PLANNING BOARD MEETING AGENDA

PLANNING BOARD MEETING MINUTES

Town of Berwick Planning Board
Conditional Use Findings of Fact
Applicant: Redimix Companies Inc.
541 Portland Street (Tax Map R-072, Lot 7-A)
April 2, 2020

Town of Berwick Planning Board
Conditional Use Findings of Fact
Applicant: Joshua Ferranto Silver Therapeutics
60 Route 236 (Tax Map R-57 Lot 55)

LAYOUT & MATERIALS PLAN

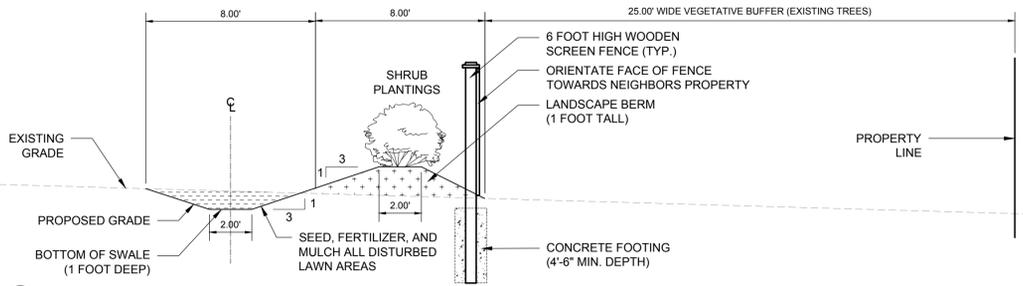
On March 5th the Planning Board held a sitewalk. One abutter was on the walk and aired concerns regarding drainage from the site impacting his property.

On March 5th the planning board held a public hearing where no one spoke regarding the project. The planning board did take up the issue of the drainage impacting the abutter and asked the applicant to revise the plan to include a small drainage swale or LID pond just off the pavement to catch the water from the new paved area. The application action was postponed until the plans can be revised.

The applicant is addressing the neighbor to the south where stormwater naturally sheet flows by adding a drainage swale or LID pond to pick up water currently impacting the neighboring property

The plans were revised and addressed the LID Pond request
